SLG46826-EV Errata Note

This document contains the known errata for SLG46826-EV and the recommended workarounds.

Figure 1: Example Data

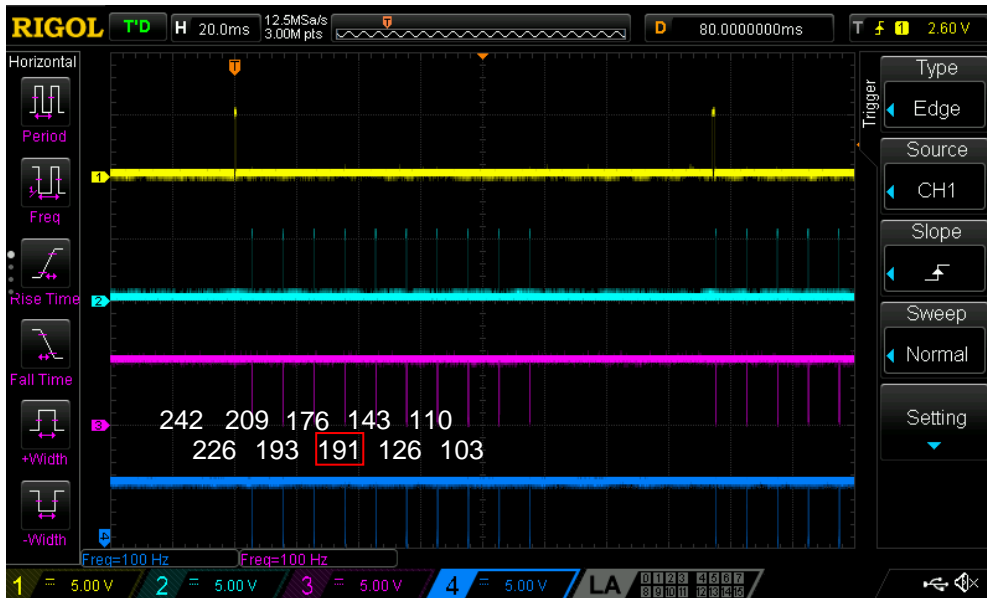
The example data capture below shows ten periodic I<sup>2</sup>C reads of CNT2/DLY2 configured to count down at about 16 clocks per read. The sixth read sample erroneously shows a value greater than that of the fifth. The seventh sample reads as if the previous I<sup>2</sup>C error never occurred - the difference from the fifth sample (176) to the seventh (143) is 33 clocks or 16 clocks + 17 clocks as expected.

If the possibility of incorrect I<sup>2</sup>C data reads can’t be accommodated for by external software checks, one can guarantee proper operation by stopping the CNT/DLY block’s clock during I<sup>2</sup>C reads through one of the following methods: by disabling the oscillator block, by reconfiguring the CNT/DLY block’s clock source, or by gating an external clock using a LUT (Look Up Table) in the signal matrix. After disabling the CNT/DLY block’s clock, the count registers can be read without error. Please note that this workaround will add the I<sup>2</sup>C read and processing time to the counter’s overall clock period.

Figure 2: GreenPAK I<sup>2</sup>C Write Frame for Page Erase

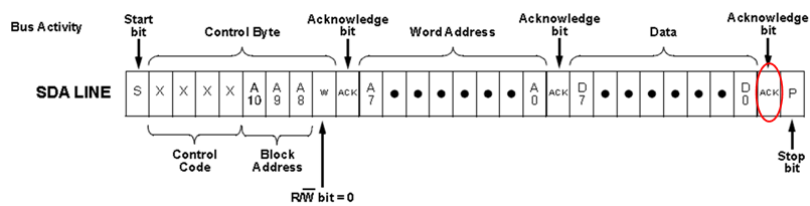
To erase the NVM and the EEPROM, one must perform an I<sup>2</sup>C write to the "Page Erase Byte" located at 0xE3. The ACK bit which follows the "Data" portion of Figure 2 won't comply with standard I<sup>2</sup>C specifications. Please see the ACK bit circled in RED below.

No workaround is required for the GreenPAK device as the NVM and EEPROM erase operations will execute properly. For verification, one can perform an I<sup>2</sup>C read of the erased pages. Excluding protected pages, all erased NVM and EEPROM registers should be cleared.

Adjust the MCU’s I<sup>2</sup>C firmware to catch and ignore a “NACK” from the GreenPAK device when the “Page Erase Byte” is addressed. In light of the additional STOP and START conditions, the behavior of other I<sup>2</sup>C slaves on the same bus should be evaluated.

Figure 3: Non-I<sup>2</sup>C Compliant Behavior Oscillogram

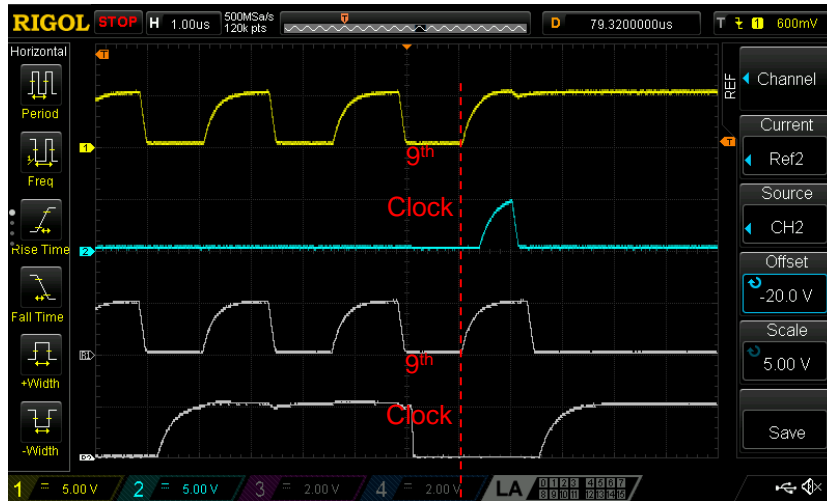
The following waveform compares the regular I<sup>2</sup>C ACK behavior (Ref 1 - SCL and Ref 2 - SDA) with the non-compliant ACK behavior (Channel 1 - SCL and Channel 2 - SDA) generated by an I<sup>2</sup>C write to the "Page Erase Byte." During the 9<sup>th</sup> clock cycle, the SLG46827-A does not adhere to the "data hold time" specification by releasing SDA (Channel 2) before the falling edge of the clock pulse on SCL (Channel 1).

On a system level, other I<sup>2</sup>C devices might interpret this non-compliant ACK as an additional STOP and START condition. By definition, a START condition occurs when SCL is HIGH and SDA transitions from HIGH to LOW. A STOP condition occurs when SCL is HIGH and SDA goes from LOW to HIGH. After the 9<sup>th</sup> clock cycle, the MCU should generate the final STOP condition to indicate the end of the transmission to all I<sup>2</sup>C slaves on the bus.

Figure 4: GreenPAK Input Structure Test Schematic

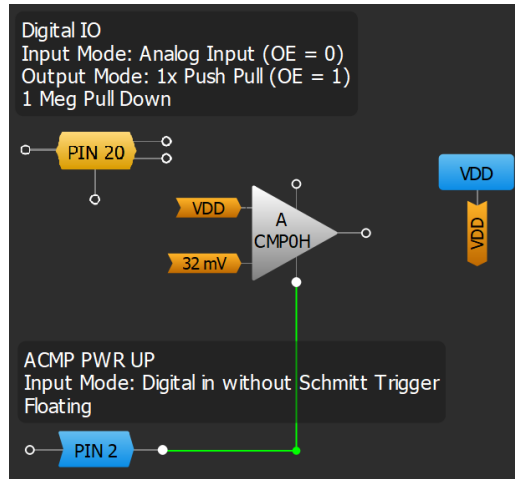
Figure 4 shows the GreenPAK configured with IO14 as a Digital IO with a 1 MΩ pull-down resistor. Since the OE pin is connected to 0 V, this pin is acting as an “Analog IO.” As seen in Table 1, IO14 and V<sub>DD</sub> are both input options for ACMP0H. In this example, IO0 is being used as a digital input to enable and disable the ACMP.

There is no workaround for this behavior. With this in mind, the IOs should not be used as digital IOs (with “Input mode” set to Analog input) or as digital outputs (with “Output mode” set to 1/2/4x 3-State Output) if the respective ACMP is enabled and connected to another input source.

Figure 5: ACMP Input Structure Behavior

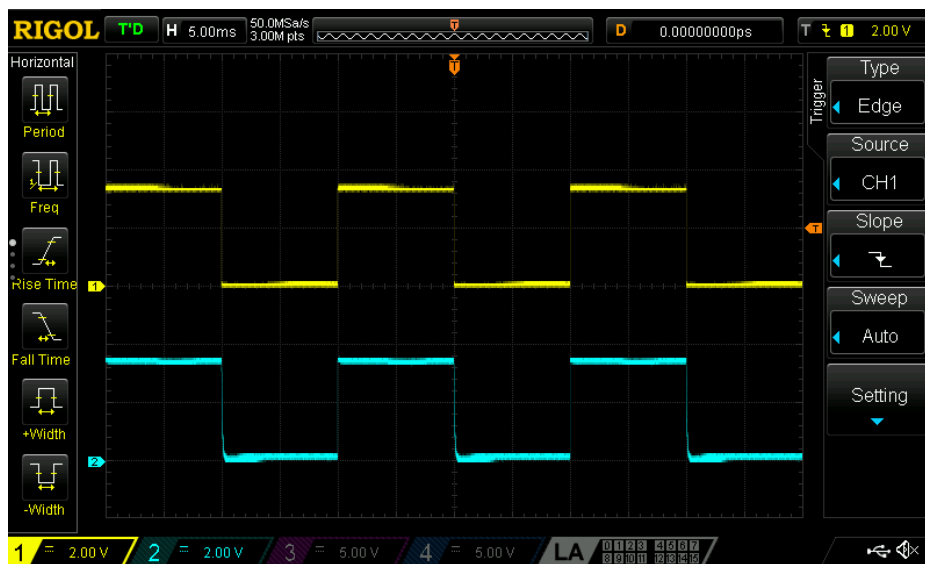
Figure 5 shows that IO14 in analog input mode is pulled HIGH by the V<sub>DD</sub> signal whenever the ACMP is enabled despite having an internal pull-down resistor. This behavior is caused by an internal connection between V<sub>DD</sub> and IO14. Similar behavior can be reproduced when one ACMP’s IN+ port is connected to another ACMP’s IN+ port.

Figure 6: Testing Design

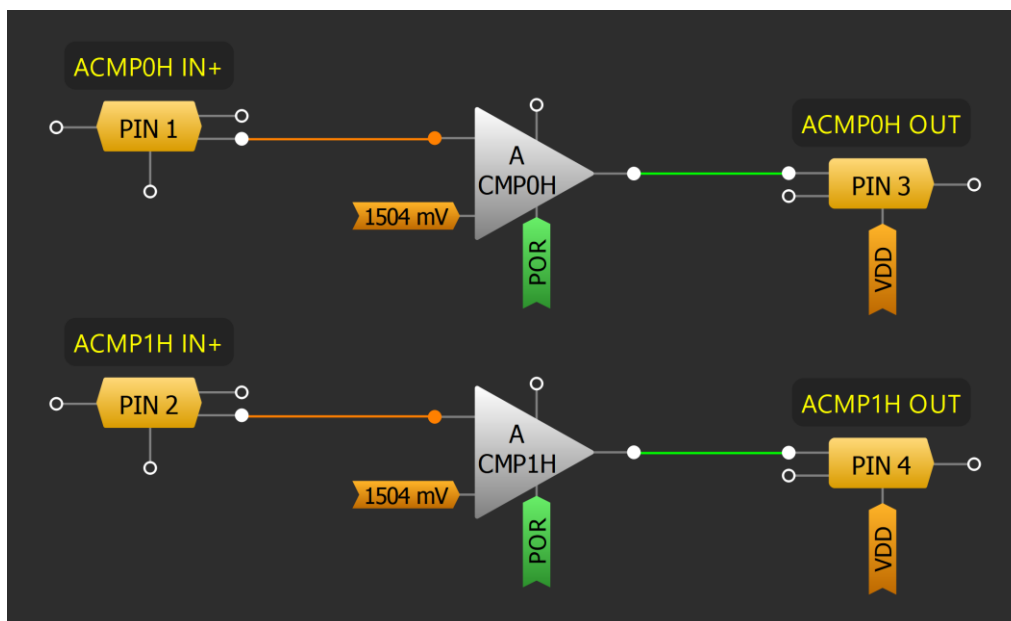
If using ACMPxH with 32 mV hysteresis, ACMPxH output could be glitching when ACMPxH positive input (IN+) is close to the negative input (IN-). It can happen when  $V_{DD} = 4.0\text{ V}$  or higher and  $V_{ref}$  ranges from 0.832 V to 1.024 V, and 1.312 V to 1.44 V.

- Use the deglitch filter connected to the ACMPxH output.
- Avoid conditions described in paragraph 3.4.2.

Figure 7: ACMP Output during Glitching

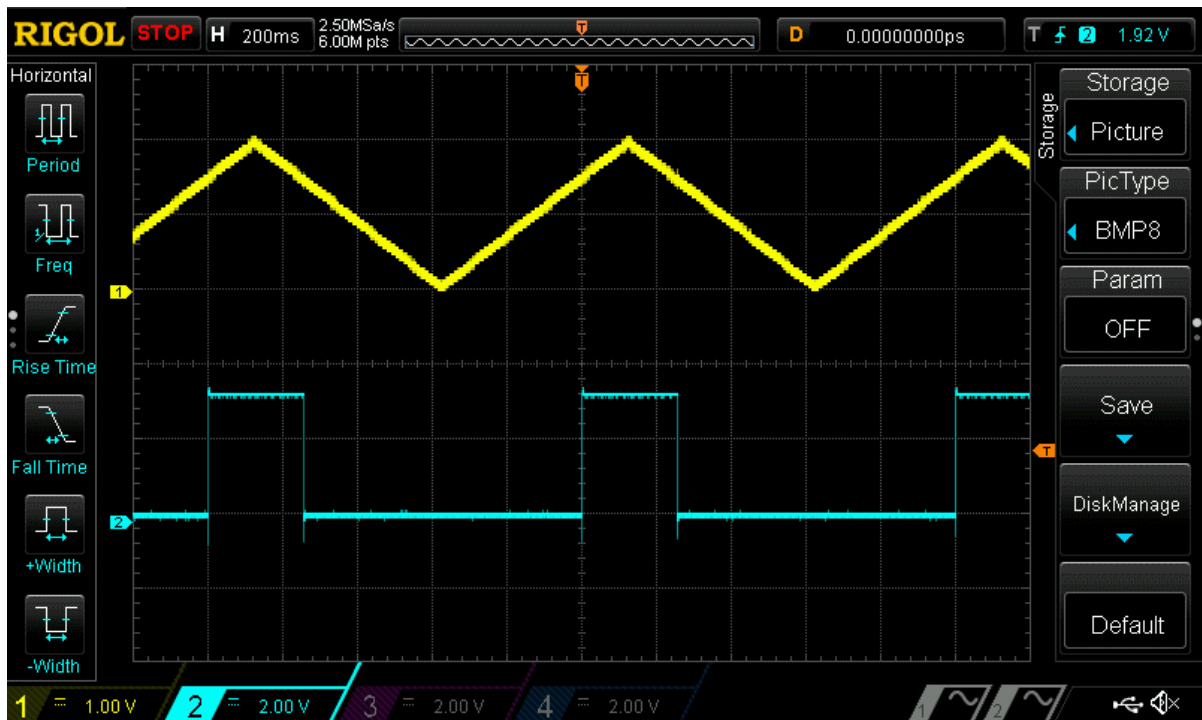
1. Waveform at  $V_{ref} = 1504\text{ mV}$ , hysteresis is equal to 32 mV.

Figure 8: Zoomed ACMP Output during Glitching

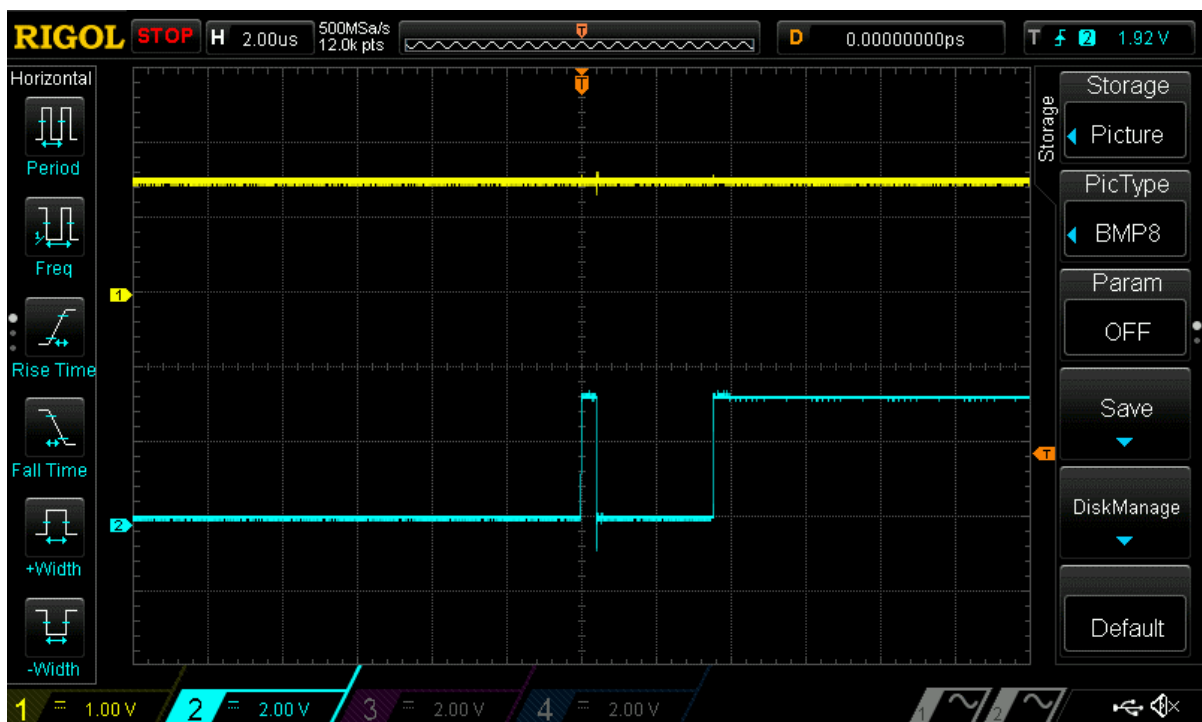
2. Waveform at  $V_{ref} = 1504 \text{ mV}$ , hysteresis is equal to  $32 \text{ mV}$  (zoomed rising edge).

Figure 9: Testing Design

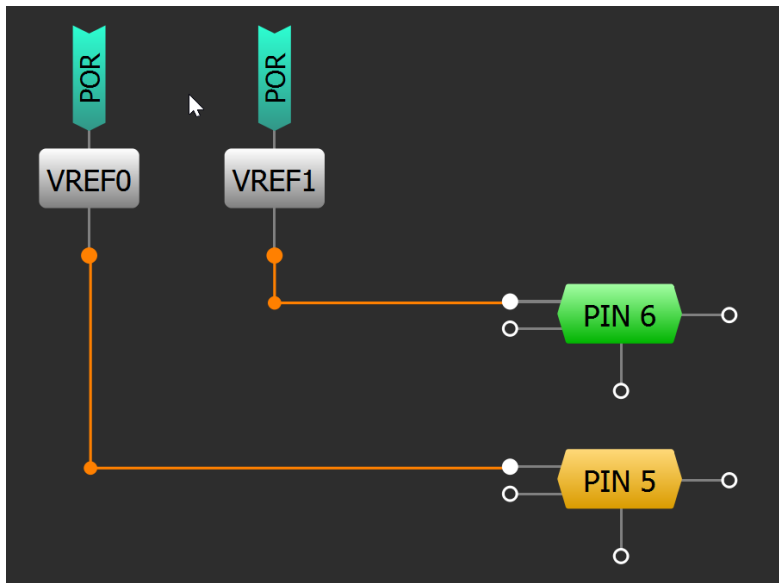
If using Vref output in the range of 32 mV to 192 mV connected to the analog input/output PIN, the Vref accuracy is very low due to the built-in buffer's offset.

There is no workaround.
